Stop and Start System - Intermittent No Restart During Wiper Operation

YEAR(S)	MODEL(S)	ADDITIONAL INFORMATION
2022 - 2023	Corolla Cross

Figure 1. Location of Authorized Modifications Label on 2022 – 2023 Corolla Cross

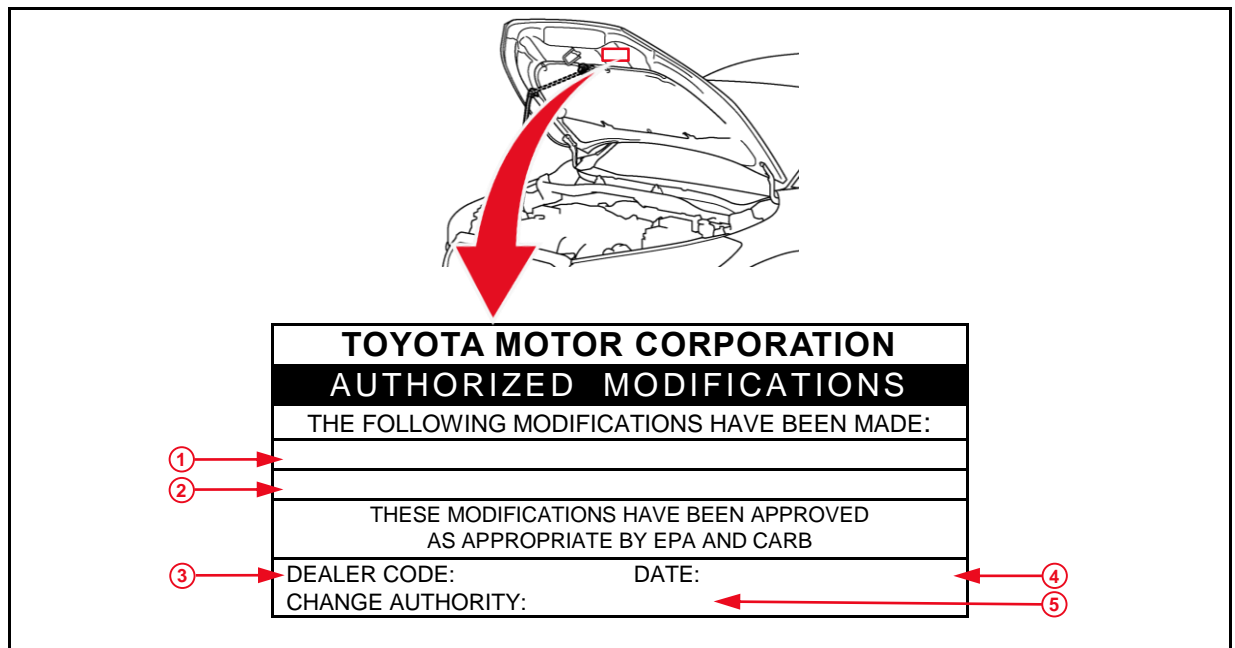
- Use Techstream to confirm if the stop and start ECM (PCM) calibration has been updated and check for the Authorized Modifications Label affixed to the vehicle in the location shown below.

Is the calibration ID listed in Techstream and on the label the latest stop and start ECM (PCM) calibration?

- Prepare and install the Authorized Modifications Label.
 - Using a permanent marker, enter the following information on the label:
 - Stop and start ECM (PCM) part number [*Refer to the **Parts Information** section for the **NEW PART NUMBER***]
 - Calibration ID(s) [*Refer to the **Calibration Information** section for the **NEW CALIBRATION ID***]
 - Dealer Code
 - Repair Date
 - Change Authority [***This bulletin number***]
 - Install the Authorized Modifications Label onto the vehicle at the location shown in Figure 1. The Authorized Modifications Label is available through the MDC, P/N 00451-00001-LBL (USA) or 00451-00002-MEX (Mexico).
- Test-drive the vehicle to confirm proper operation.
